Service Bulletin

Bulletin No.: 22-NA-060

Subject: Information on Possible Tick or Rattle Noise Concern from Left and/or Right Side Rocker Cover

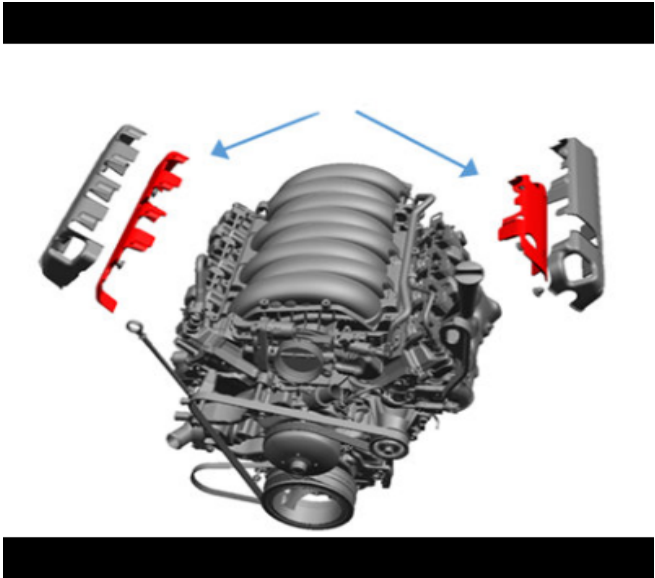
Involved Region or Country	North America
Condition	Some customers may comment that they hear a tick or rattle type noise coming from the engine compartment – This noise may be noticeable on the top of the engine near the left or right-side rocker cover area.

<p>Cause</p>	<p>This condition may be caused by the left or right side rocker cover insulator.</p> <ul style="list-style-type: none"> – For a short period of time the insulator was manufactured without the fiberglass insulation (as indicated in the graphic below) that is used to reduce the normal engine valvetrain noise. This was due to an unavoidable supply shortage issue. Without this fiberglass insulation an increase in valvetrain noise on that bank may be noticeable.  <p style="text-align: right;">6018737</p>
<p>Correction</p>	<p>If you encounter a vehicle with this condition and the noise is unacceptable to the customer, you can install a service cover which has the insulation attached to the insulator to help reduce the valvetrain noise.</p>

Refer to *Valve Rocker Arm Cover Insulator Replacement - Left Side* in the Service Manual and/or *Valve Rocker Arm Cover Insulator Replacement - Right Side* in the Service Manual.
